Figure 2.1c

Infrastructure Design Review
- Turbine 03

Bhlaraidh Wind Farm Extension
S36C Varied Development

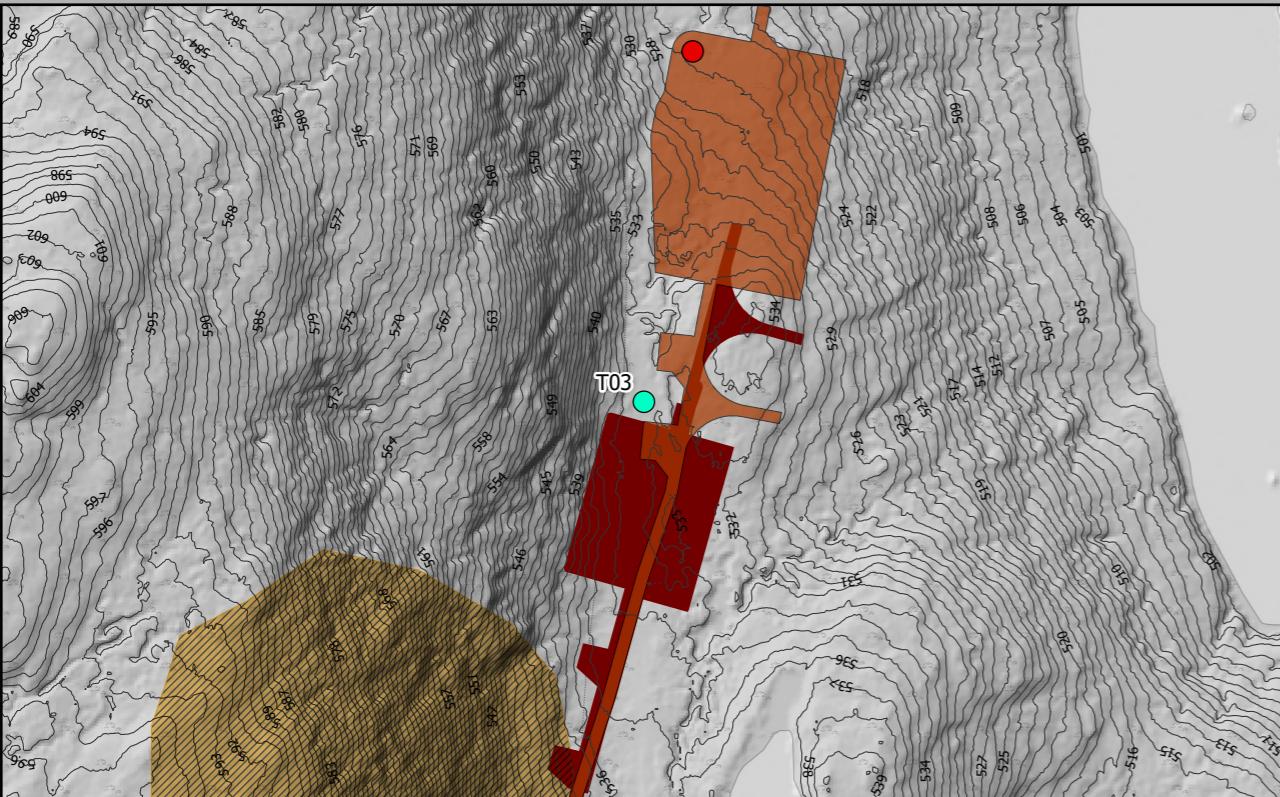
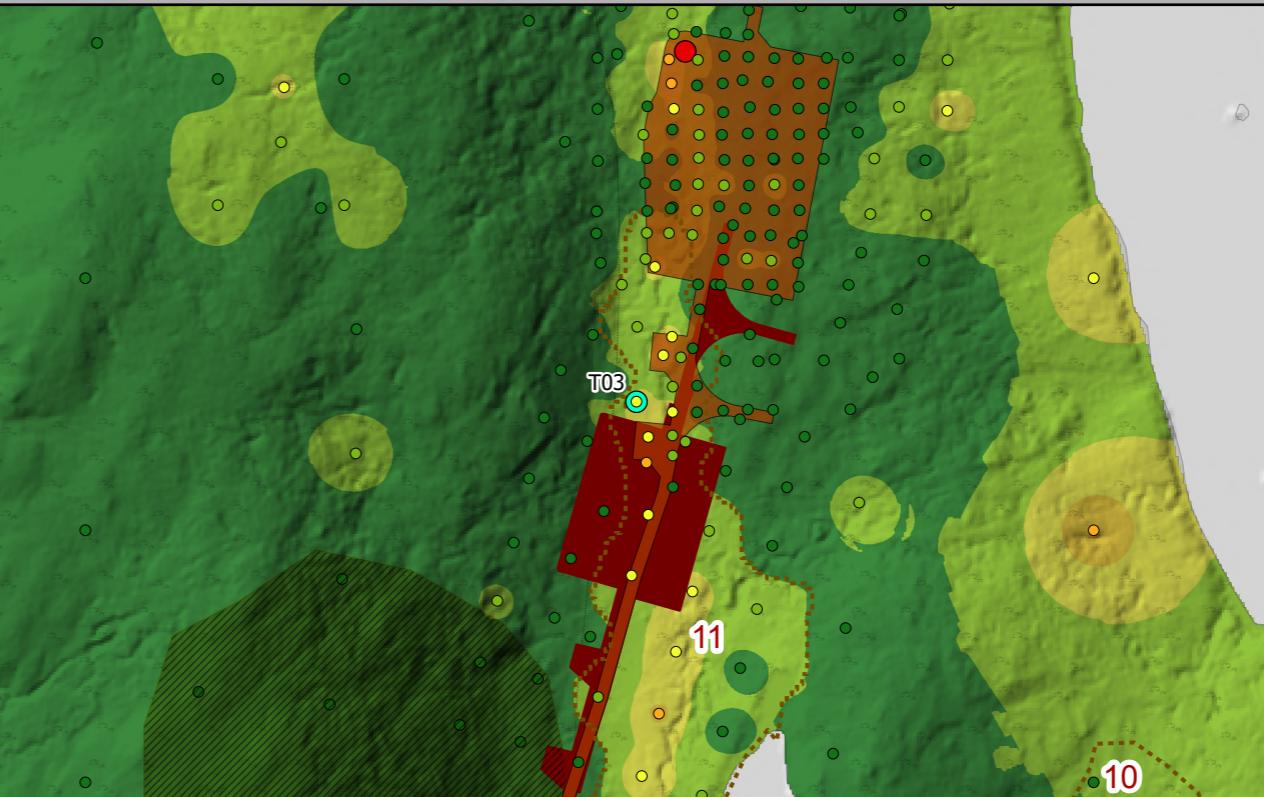
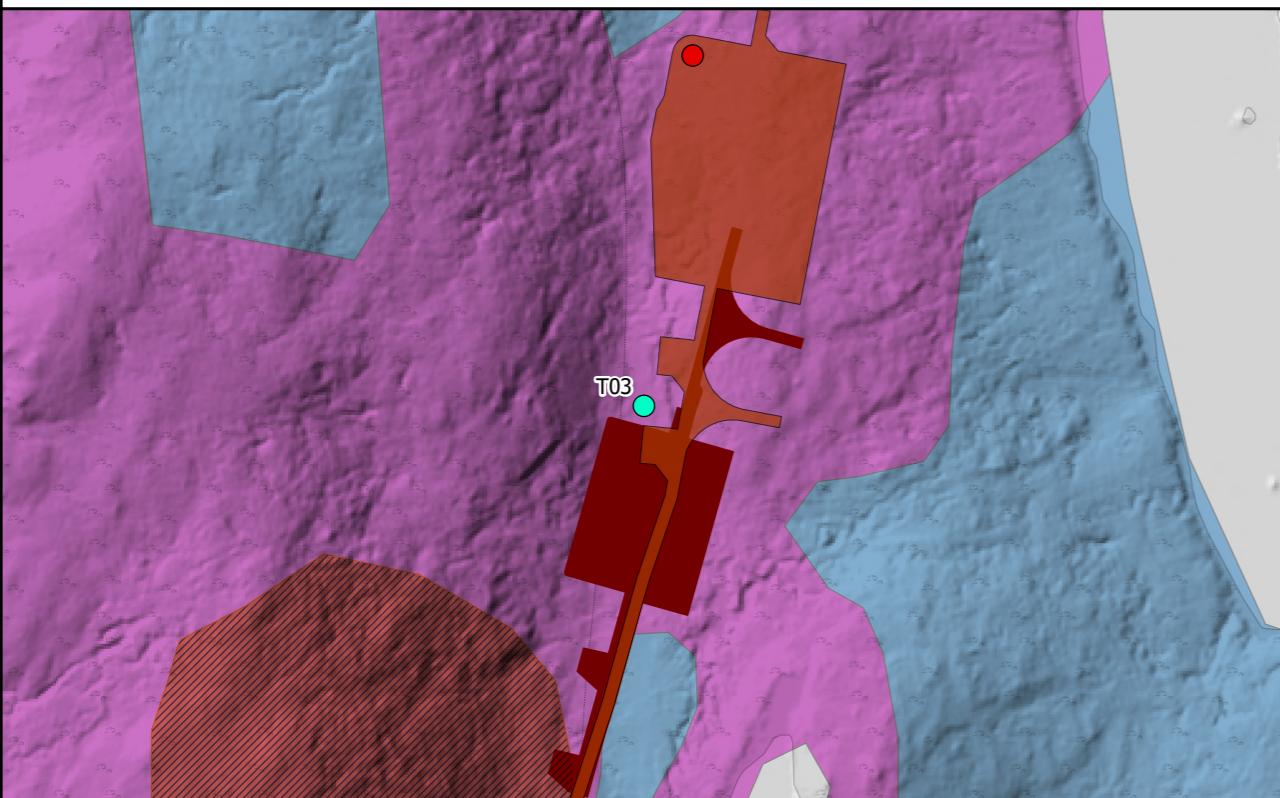
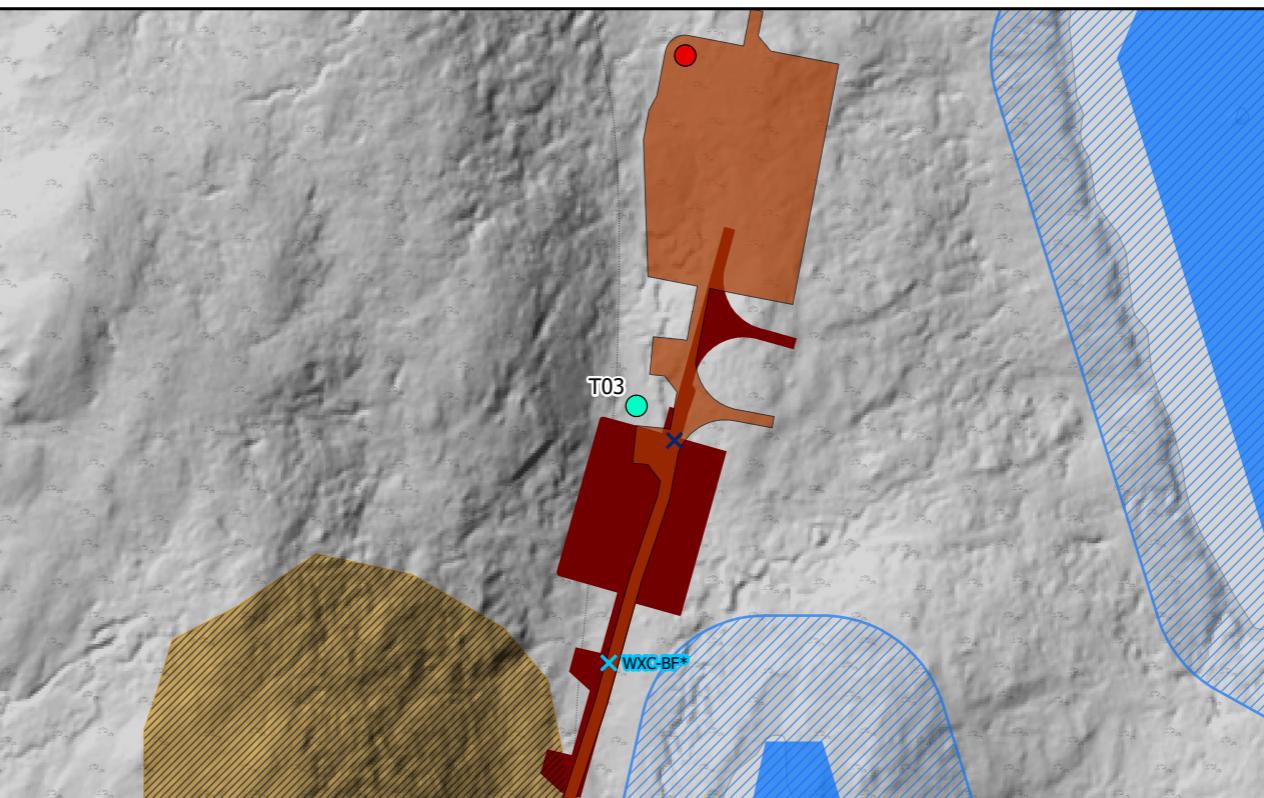
T03: Reason for Moving: The move is necessary to increase turbine spacing to more than three times the rotor diameter from its closest neighbouring turbine. This adjustment was needed because T11 had to be moved north due to safety concerns regarding the toppling distance to the substation platform. Increasing the spacing reduces the impact of wake-related losses, which occur when turbines are too close to each other. This turbine is already significantly affected by the Carn Tarsuinn hill directly to the west of T03.

Engineering: The new location makes use of a relatively flat section of ground to the North of the consented location, removing /minimising disturbance of the extremely steep slopes of Carn Tarsuinn to the West.

Geology Impacts: The proposed turbine location is on flatter ground, which reduces construction disturbance to the east slope of Carn Tarsuinn hill. The new hardstand location is outside the current consented 50m micrositing buffer and is in an area with shallower peat compared to the current consent. Additionally, the new location is further from the HMP Peatland Restoration area.

Ecology Impacts: Infrastructure remains within the same NVC survey habitat type (M15c).

Hydrology Impacts: The proposed infrastructure location is further from water buffers compared to the currently consented location. As per the current consented location, a water course crossing is required on the track at the entrance to the hardstand.
